MONTICELLO NUCLEAR GENERATING PLANT
Docket No. 50-263 License No. DPR-22

Replacement of Spent Fuel Pool Storage
Racks - Supplement 1

Response to 10/25/77 NRC
Request for Additional Information
on
Monticello Replacement of
Spent Fuel Pool Storage Racks

FIGURE 1

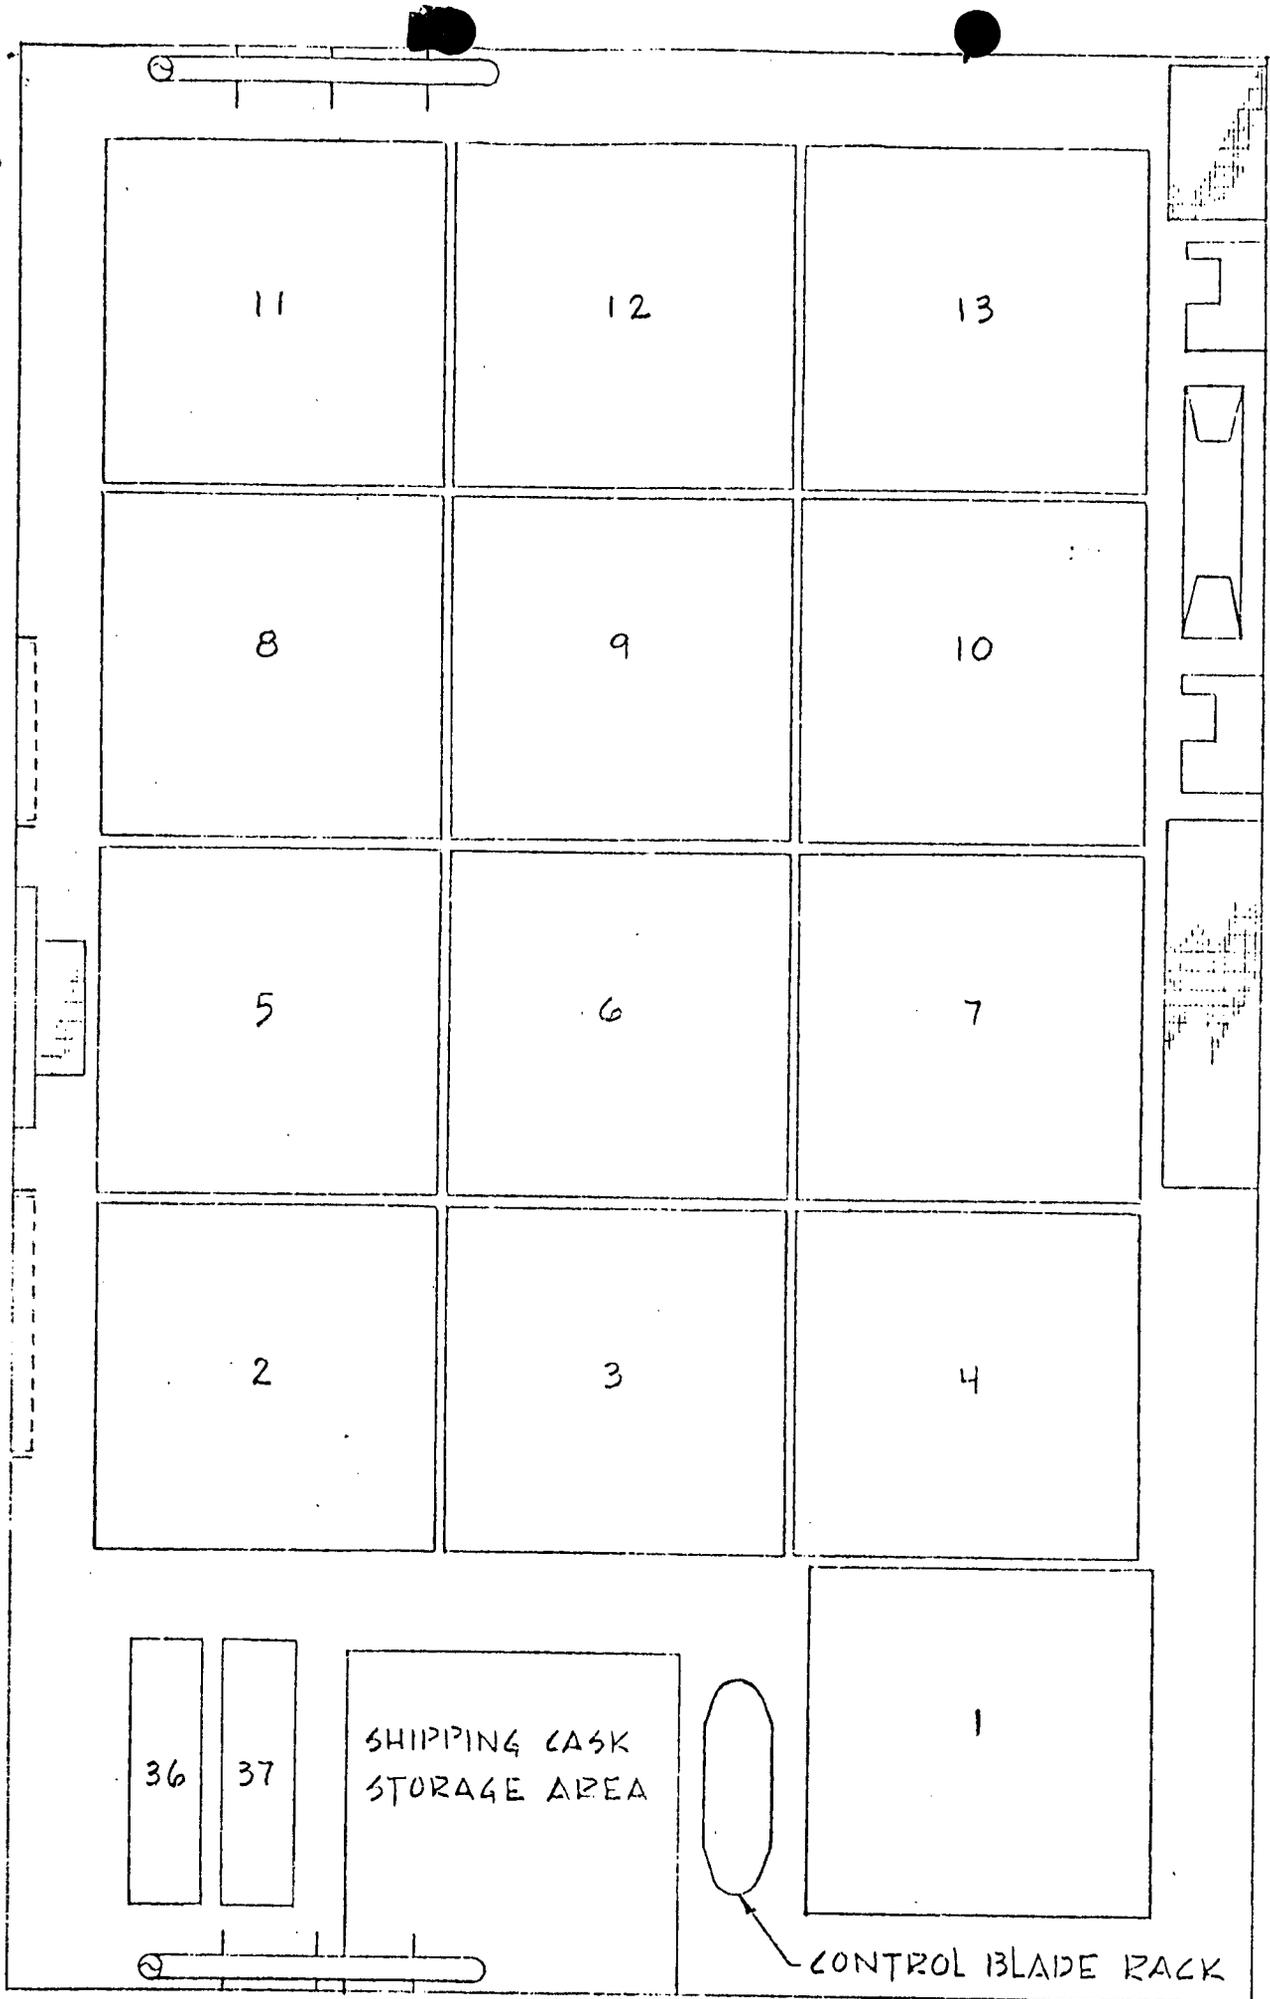
Q.12 Describe the procedures that will be used to remove the present racks and install the new ones. Specifically, discuss how you will preclude the possibility of dropping or tipping a rack onto the spent fuel in the pool.

A.12 The spent fuel storage modification at Monticello will be carried out in two or more phases. The first phase entails placement of new spent fuel racks (hereafter called modules) 1 through 4 in locations shown on the attached Figure 1. Placement of modules 5 through 13 will occur as a later phase or phases as modules become available from the manufacturer.

- C. Vertical movement of racks and modules in and out of the pool will be done in designated areas. All racks removed from the pool in preparation for the first phase will be lifted from the southeast corner of the pool. Modules 1 through 4 will be lowered into the southeast corner of the pool. All other racks removed from the pool will be lifted from the northwest corner of the pool. Modules 5 through 13 will be lowered into the northwest corner of the pool.
